Re: **PETITION NO. 1492** – CT NSB ProjectCo LLC petition for a declaratory ruling, pursuant to Connecticut General Statutes §4-176 and §16-50k, for the proposed construction, maintenance and operation of a 1.99-megawatt AC solar photovoltaic electric generating facility located at 486 Fitch Hill Road, Montville (Uncasville), Connecticut, and associated electrical interconnection.

**Petition No. 1492**  
**CT NSB ProjectCo LLC**  
**486 Fitch Hill Road, Montville**

**Interrogatories**

SHEET NUMBER:  
**OP-2**

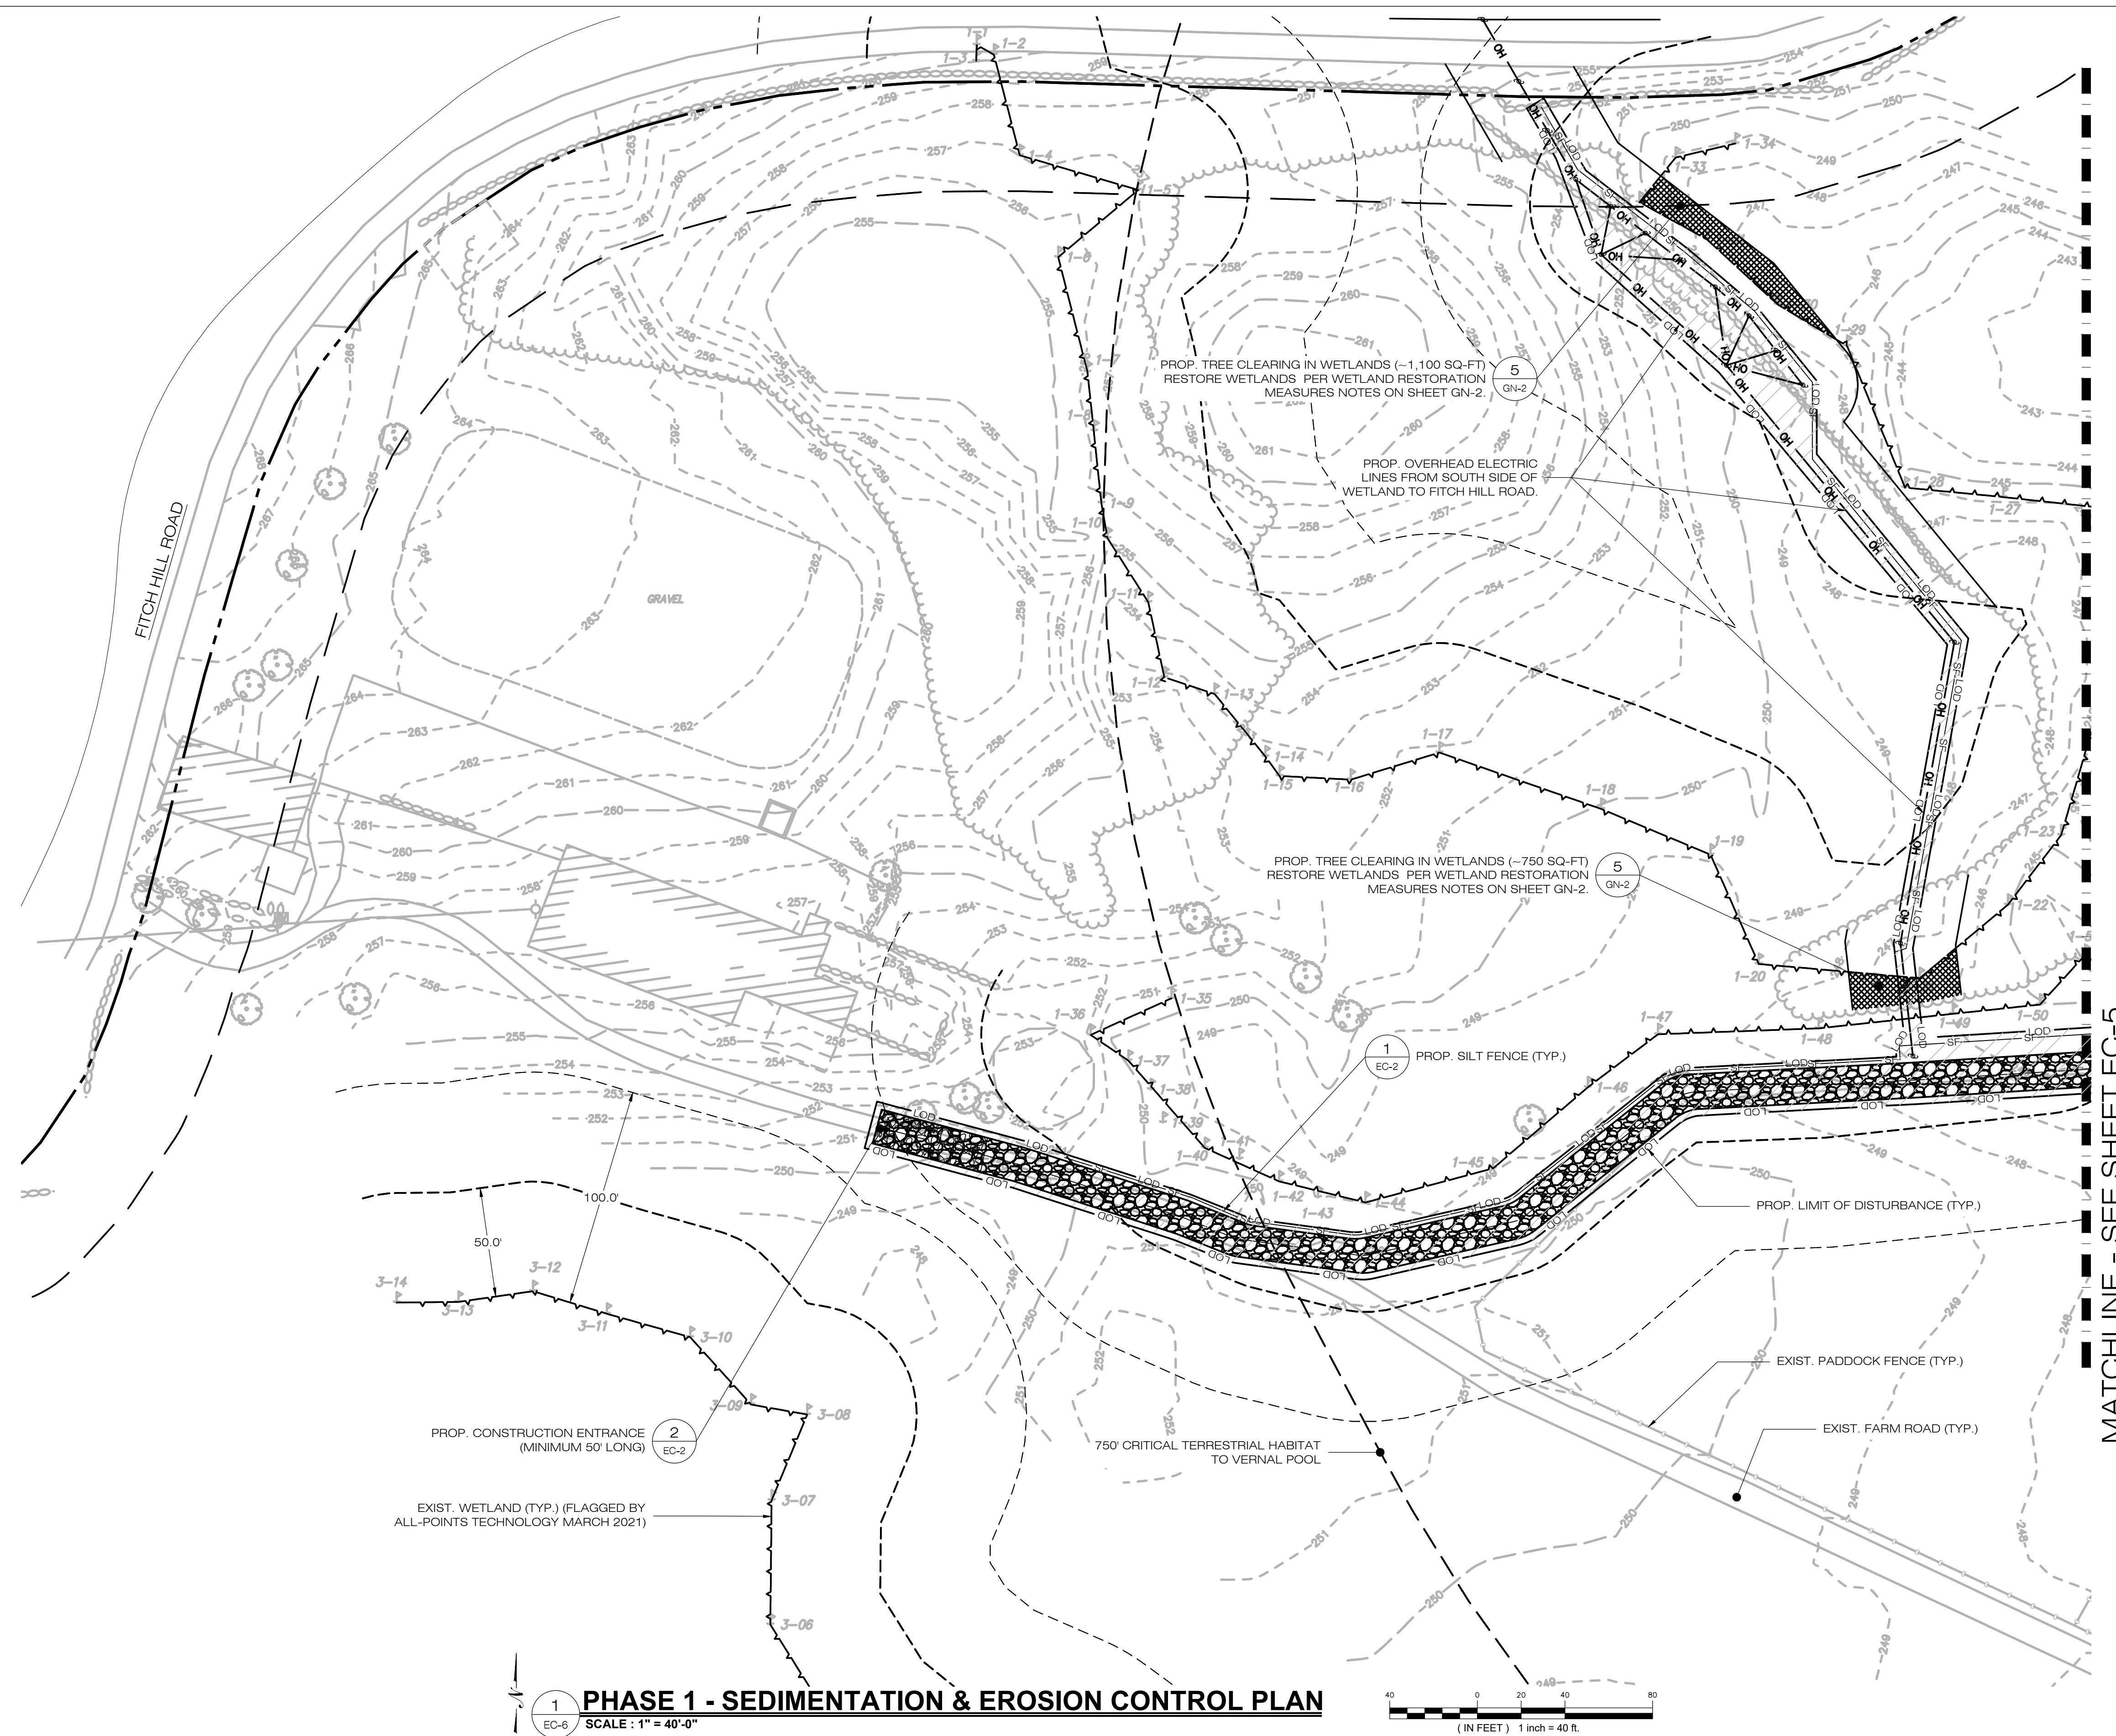
18. Referring to Site Plan OP-2, what is the Town of Montville's Zoning Building Setback Line? Can the Project be altered so that the solar array remains out of the Zoning Building Setback Line?

19. Referring to Site Plan OP-2, a shading limit is shown south of the solar array area. Does this limit represent shading after or before site clearing?

**The shading limit shown on Site Plan Sheet OP-2 represents shading after the proposed clearing activities.**
